Promulgation of Air Quality)	
Implementation Plans; State of)	
Arkansas; Regional Haze and)	Docket No. EPA-R06-OAR-2015-0189
Interstate Visibility Transport)	
Federal Implementation Plan;)	
Final Rule)

**PETITION FOR RECONSIDERATION AND REQUEST FOR
ADMINISTRATIVE STAY**

Comments on the Use of the CALPUFF Model in the US Environmental Protection Agency's Federal Implementation Plan for the Regional Haze Rule in Arkansas

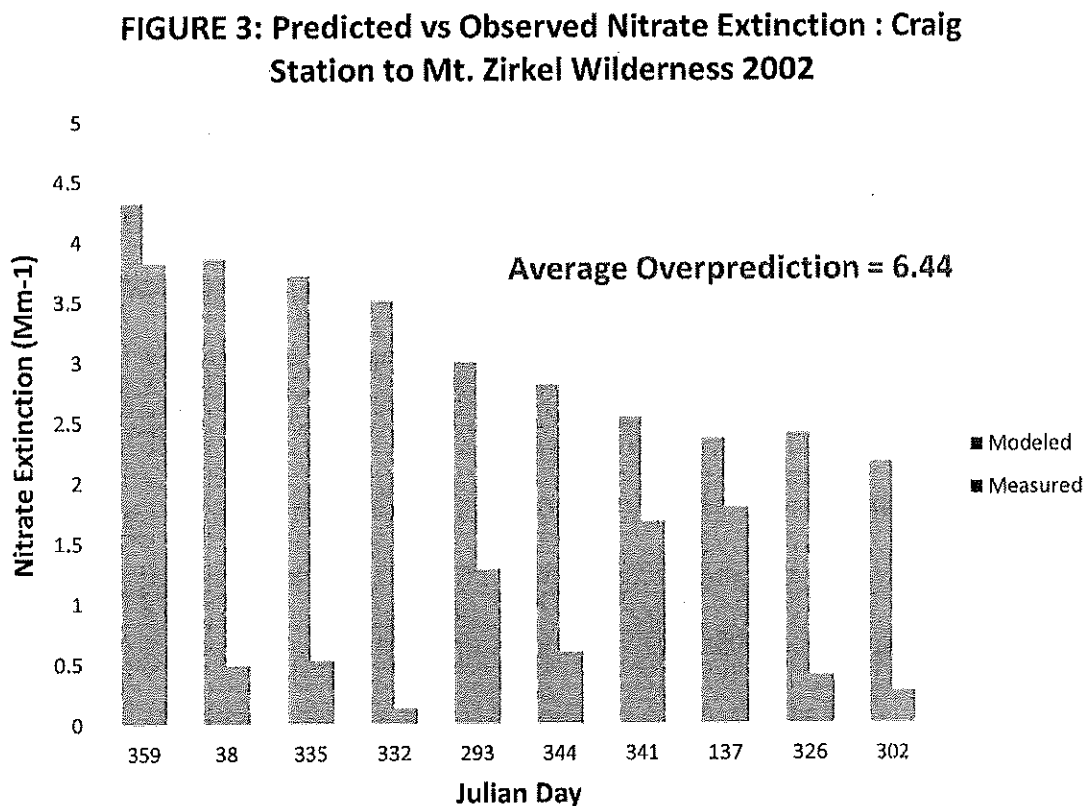
The modeled results exceed the observed in Figure 2 by 17% (the bias) and the margin of error is 38%. That result assumes that Craig Station is the only contributor to extinction at Mt. Zirkel, which clearly is not true. When Hayden Station is added to the evaluation, the modeled exceeds the observed by 61% (the bias) and the margin of error is 132%. There are, of course,

FIGURE 4: Presentation of the Results in Table 3

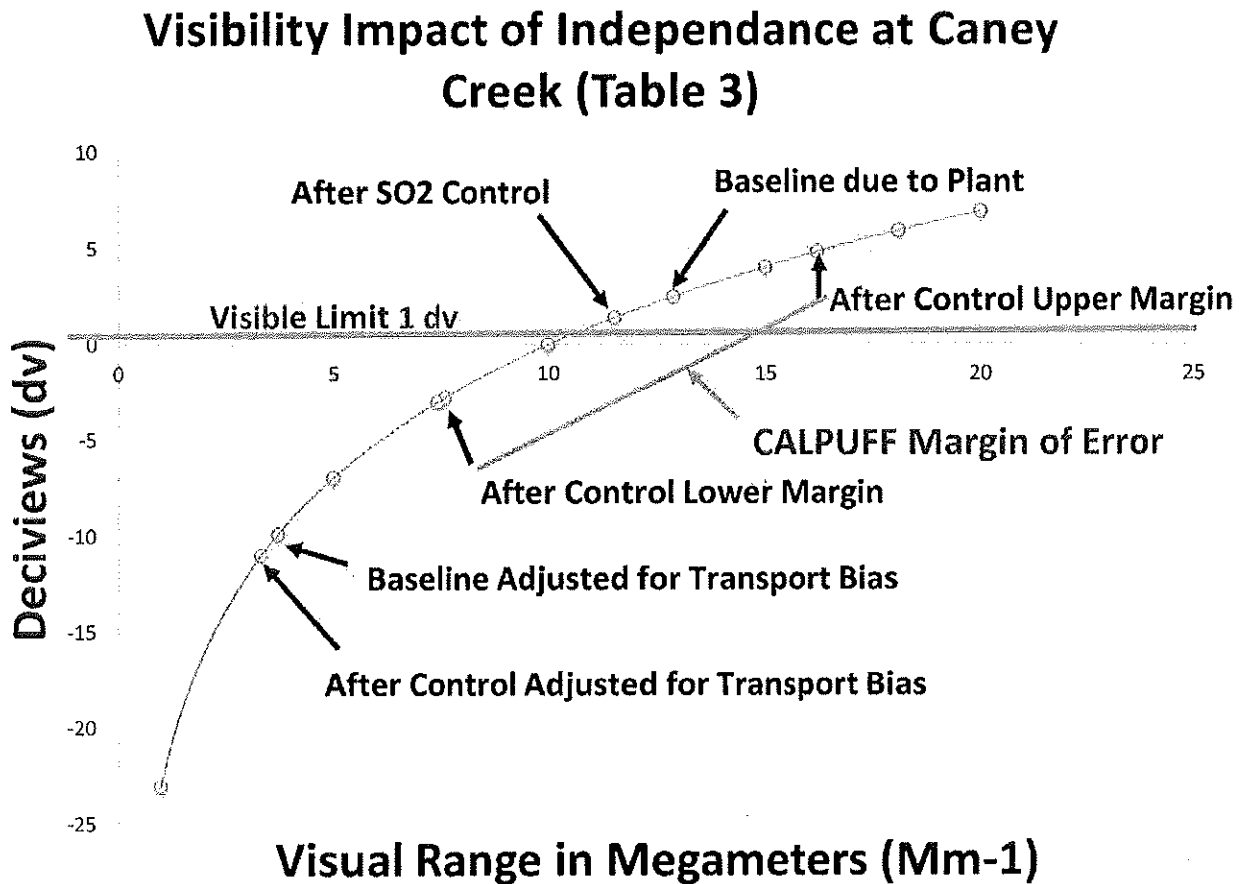
The Table 3 results show that correcting for dispersion and transport bias would result in no visibility impact from the Independence Plant. The Table 3 results show that utilizing the transport and diffusion margin of error (without accounting for the bias), the EPA CALPUFF model results show too large a margin of error to conclude that that requiring dry FGD on the

Independence Plant would assure an improvement in visibility. The margin of error is from 4.85 Mm-1 to not visible at all.
